Resubmittal of Electrical Door and Panel per 064116-003 Detail 3/7.

WEBSTER UNIVERSITY ISB
PROJECT NAME

PROJECT: 15051-Webster University Interdisciplinary Science Building

RE: plastic laminate faced architectural cabinets shop drawings

2/05 Elevation at Paneling 3rd Floor
3/8"= 1'-0"

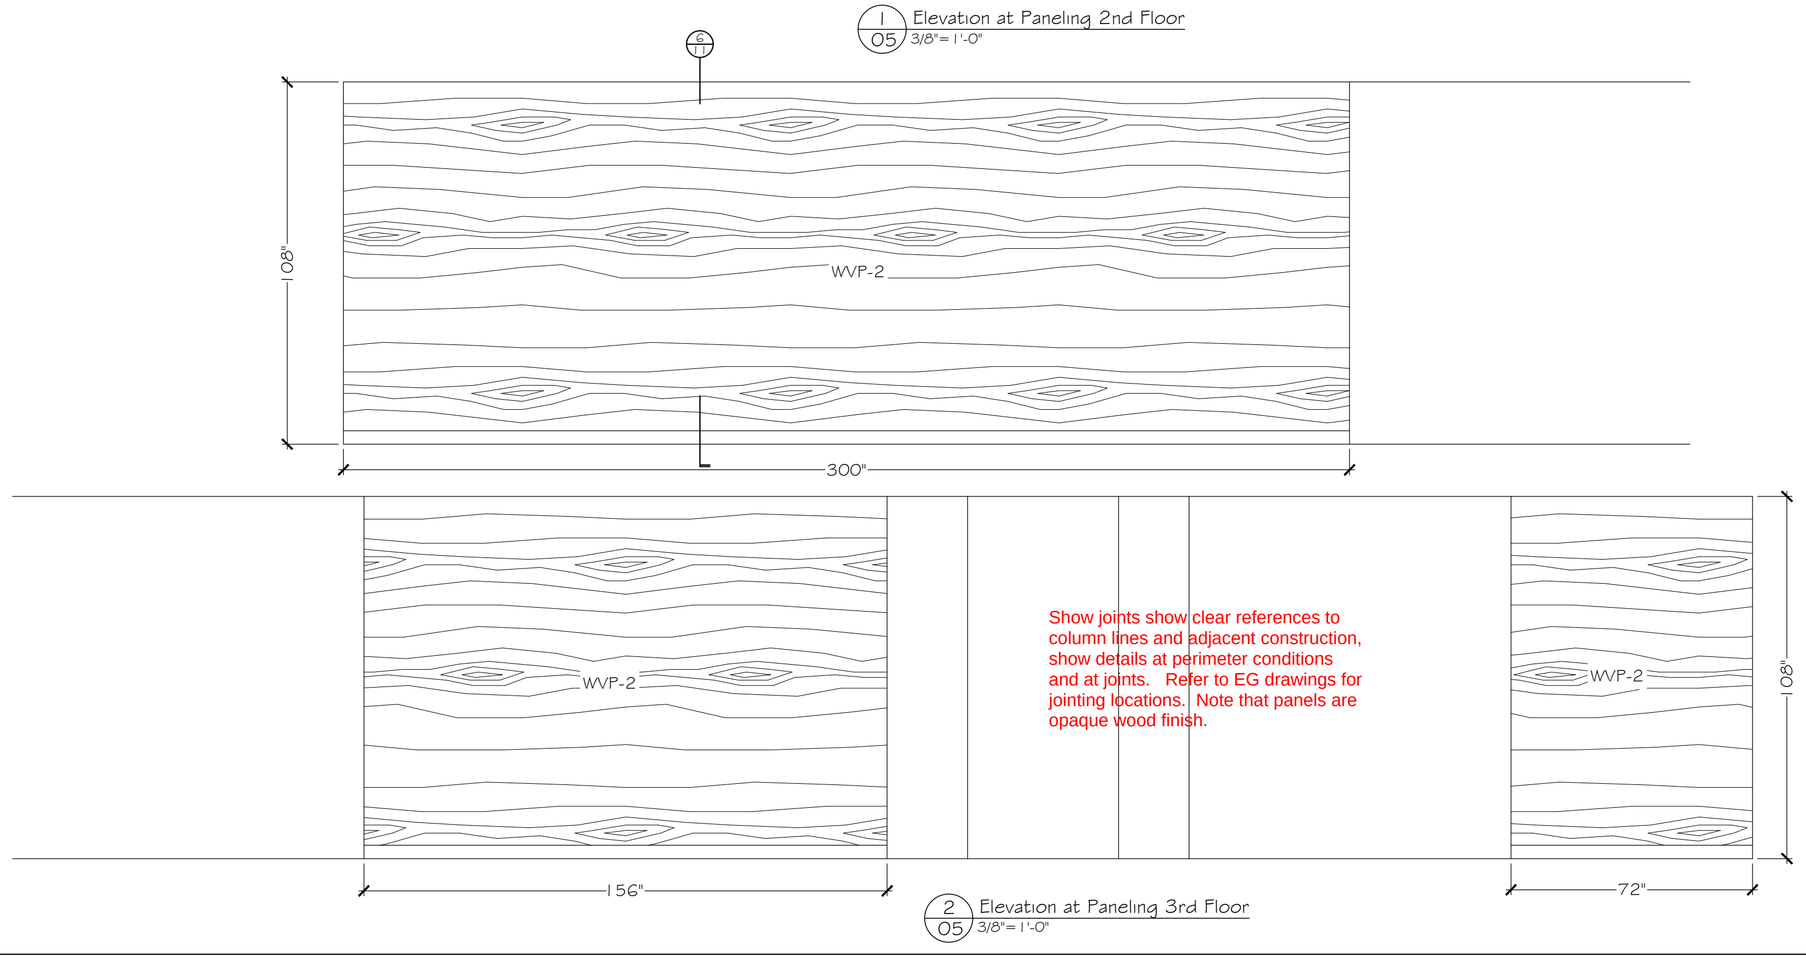
Show joints show clear references to column lines and adjacent construction, show details at perimeter conditions and at joints. Refer to EG drawings for jointing locations. Note that panels are opaque wood finish.

1/06 Elevation at Paneling 4th Floor
3/8"=1'-0"

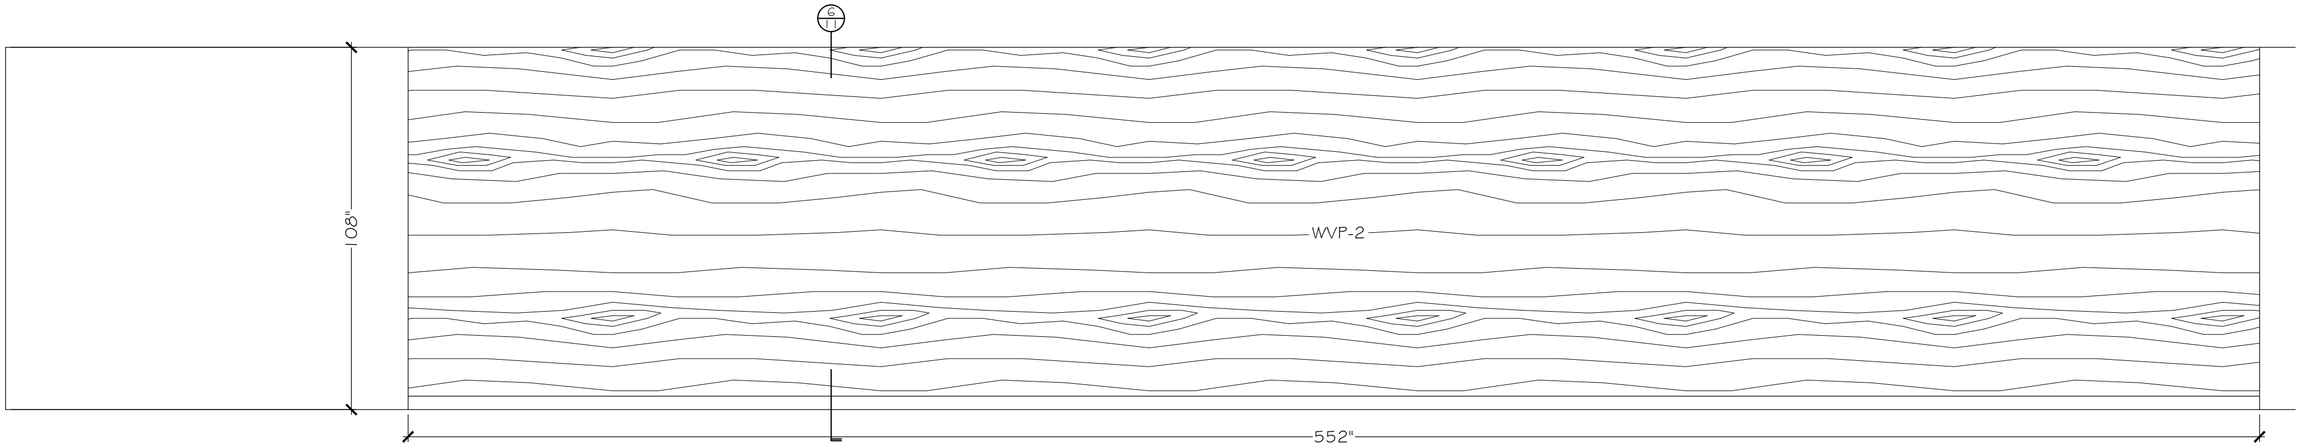
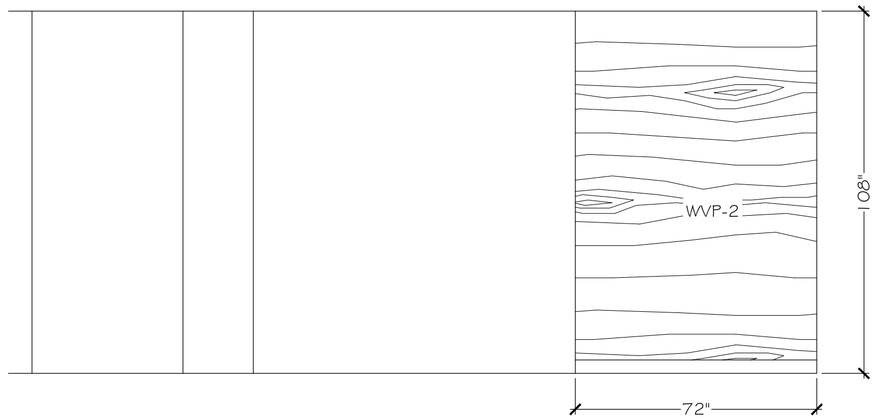
Show joints show clear references to column lines and adjacent construction, show details at perimeter conditions and at joints. Refer to EG drawings for jointing locations. Note that panels are opaque wood finish.

not reviewed. provide full scope of wood soffit and jamb panels. provide both locations at electrical panels with doors and fixed panel locations. Provide plan locations, and all details.

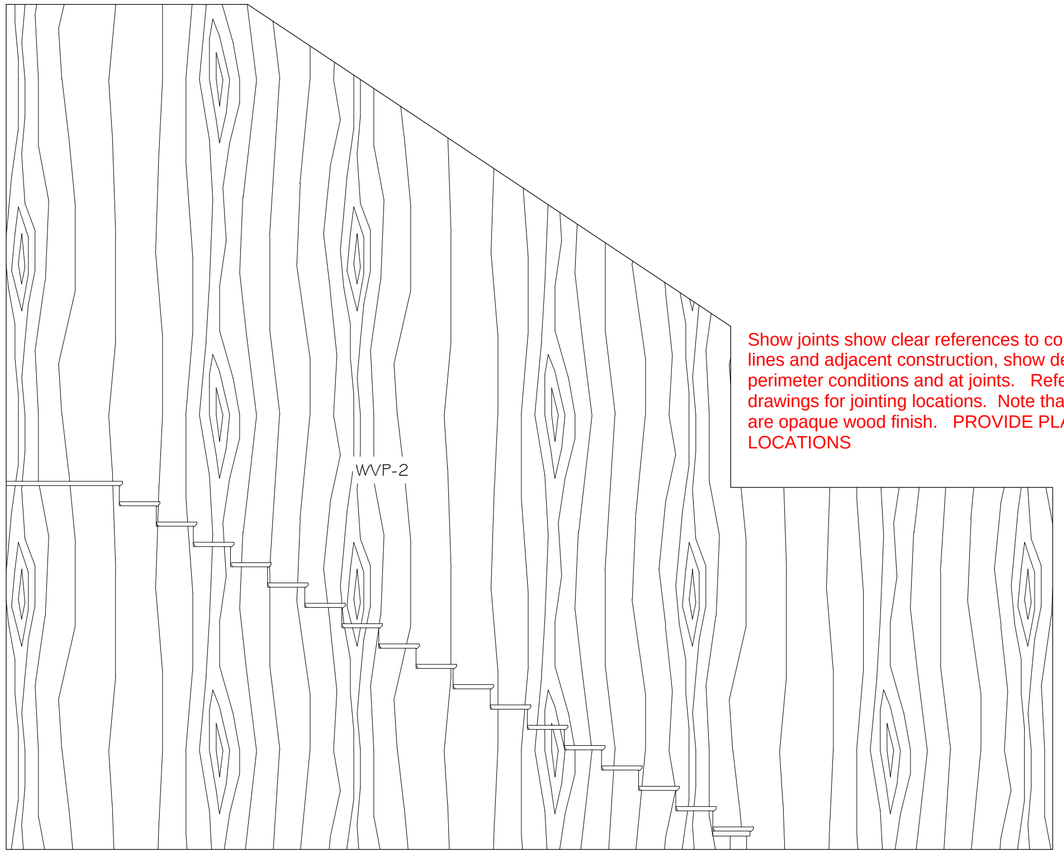
Show joints show clear references to column lines and adjacent construction, show details at perimeter conditions and at joints. Refer to EG drawings for jointing locations. Note that panels are opaque wood finish. PROVIDE PLAN FOR LOCATIONS

5 / 07 Plan and Elevation at Cold Room 376 3/8"=1'-0"

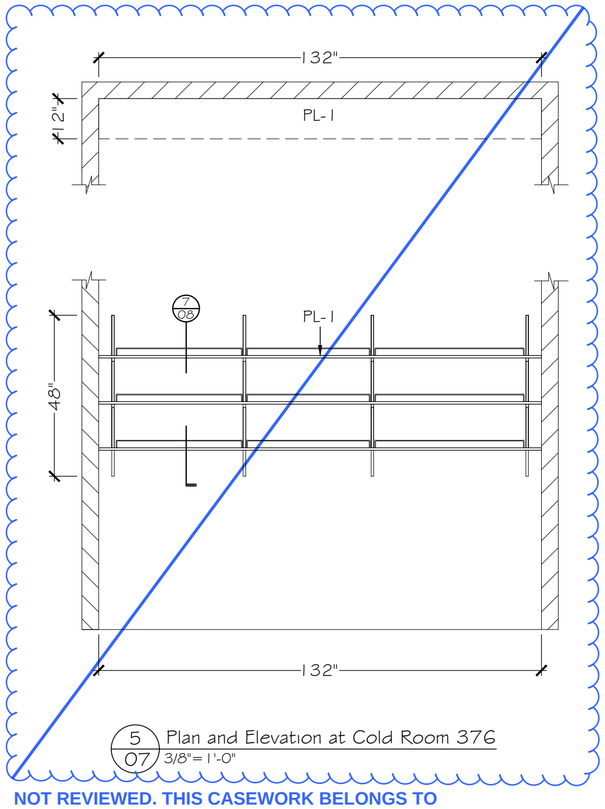
NOT REVIEWED. THIS CASEWORK BELONGS TO SPECIFICATION 123553 LAB CASEWORK SUBMITTAL. THE WALL MOUNTED SHELVING TO BE SAME AS THE SHELVING PROVIDED FOR MOBILE LAB BENCHES.

5/08 Section at Base Cabinet
1 1/2"= 1'-0"

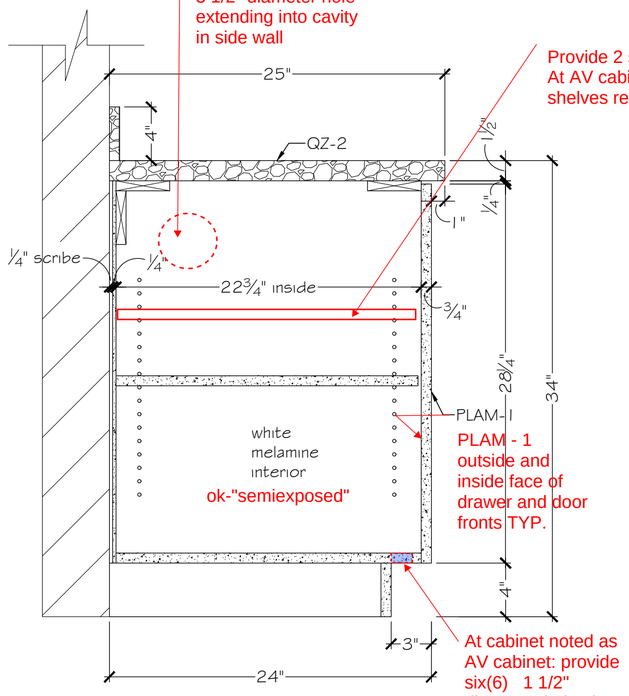
Provide 2 shelves. -
At AV cabinet - no
shelves required

PLAM - 1
outside and
inside face of
drawer and door
fronts TYP.

At cabinet noted as
AV cabinet: provide
six(6) 1 1/2"
diameter holes in
base

7/08 Section at Shelves
1 1/2"= 1'-0"

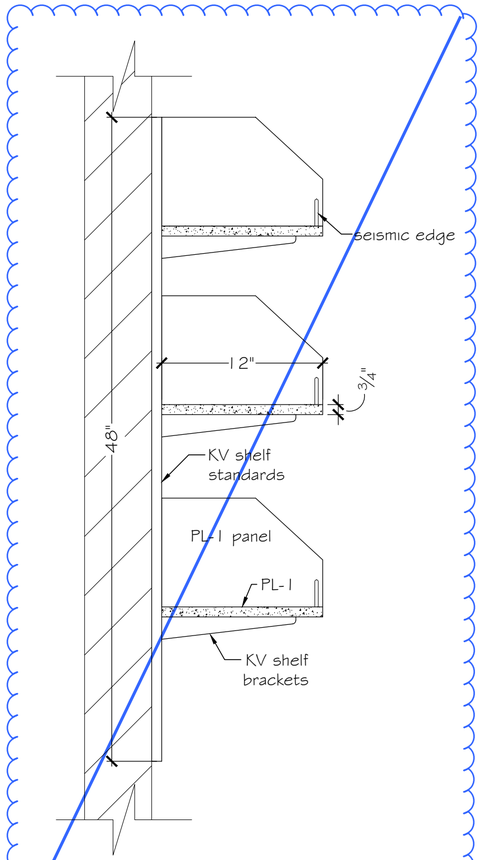
NOT REVIEWED. THIS CASEWORK BELONGS TO SPECIFICATION 123553 LAB CASEWORK SUBMITTAL. THE WALL MOUNTED SHELVING TO BE SAME AS THE SHELVING PROVIDED FOR MOBILE LAB BENCHES.

5 / 10 Section at Base Cabinet
1 1/2"= 1'-0"

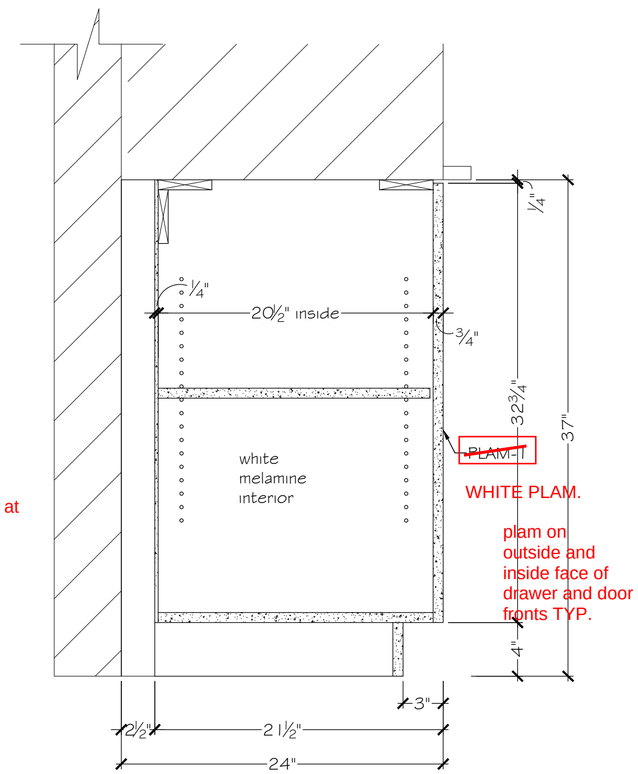
ROOM 154:
DETAIL TO BE AS
SHOWN WITHOUT
MARKUPS - USE DETAIL
5 ON SHEET 11

UPDATE TO ASI 035
NOTE THAT 19 1/2"
INTERIOR REQ'D

6 / 10 Section at Base Cabinet
1 1/2"= 1'-0"

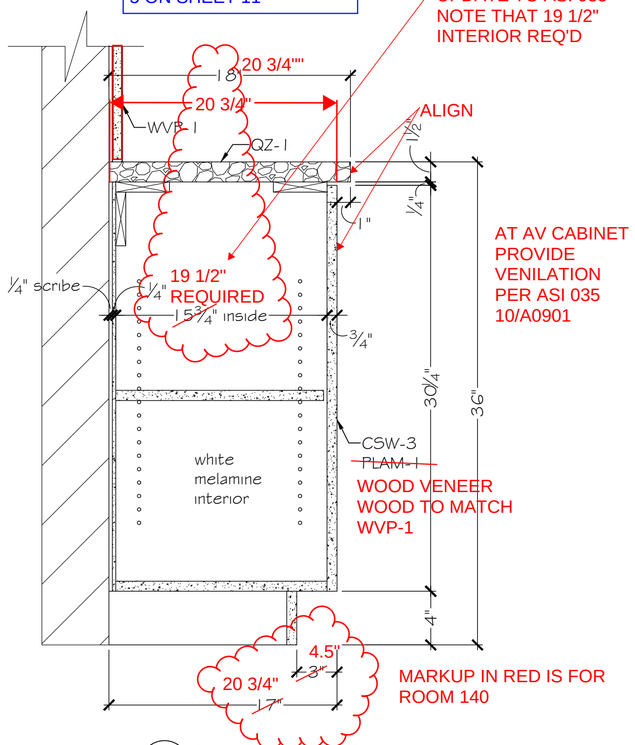
MARKUP IN RED IS FOR
ROOM 140

5 Section at Base Cabinet
1 1/2"=1'-0"

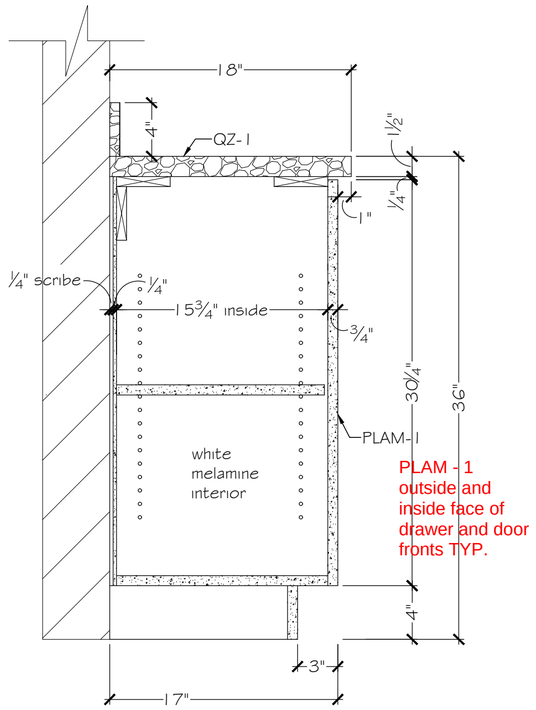
use this detail
for Room 154
